T-SB-0017-23 April 12, 2023

MIL ON With DTC P05A074

Some 2018 – 2020 model year Camry Hybrid and 2019 – 2020 model year Avalon Hybrid vehicles equipped with a A25A-FXS engine may exhibit a MIL ON condition with Diagnostic Trouble Code (DTC) P05A074 (Active Grill Air Shutter "A" Actuator Slipping). To address these concerns an updated radiator shutter sub-assembly was developed. Follow the Repair Procedure in this bulletin to address this condition.

Figure 1. Vehicle Speed

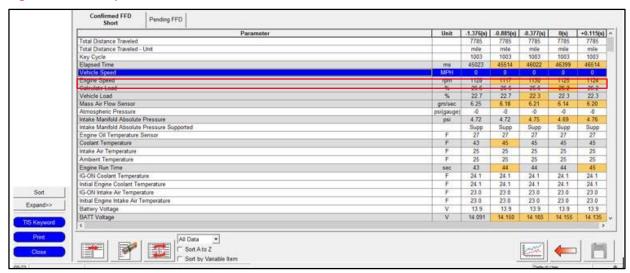
- Confirm the condition exists.
 Using Techstream, check for stored DTCs.
 Is DTC P05A074 (Active Grill Air Shutter "A" Actuator Slipping) present?
 - YES Continue to step 2.
 - NO This bulletin does NOT apply. Continue diagnosis using the applicable Repair Manual.
- 2. Read the freeze frame data for DTC P05A074.
- 3. Is the vehicle speed greater than 75mph/120kmh?
 - YES Continue to step 4.
 - NO This bulletin does NOT apply. Continue diagnosis using the applicable Repair Manual.
